Service-Bulletin

Dishwashers

599 512 547 EN

Dishwashers for installation in height

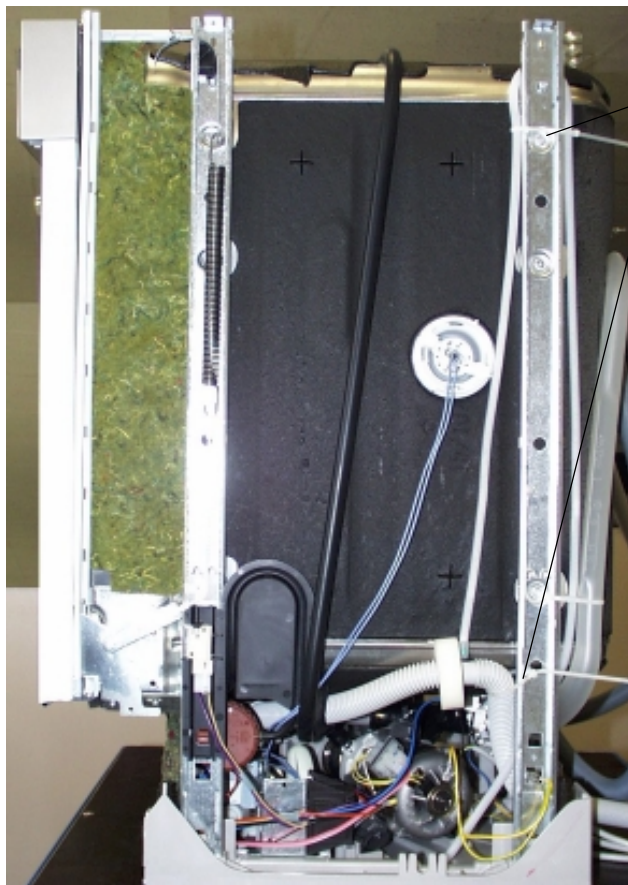
Dishwashers for height installation which are not yet equipped with discharge hose ventilation, can be reequipped by customer service if any problems should arise.

The kit has **PN 407133490/0** and is installed as shown on the image.

If necessary, you should reuse the angular bush from the old discharge hose.

As all the regenerating distributors do not have connection pieces for the ventilation hose, customer service may install the ventilation hose in other than standard ways. As the figure shows, the ventilation hose is installed, on the one hand, up to upper edge of the machine and then into the base trough. Although the ball valve at the beginning of the ventilation hose might not close perfectly, no water will penetrate into the base trough, even if the machine is installed in height.
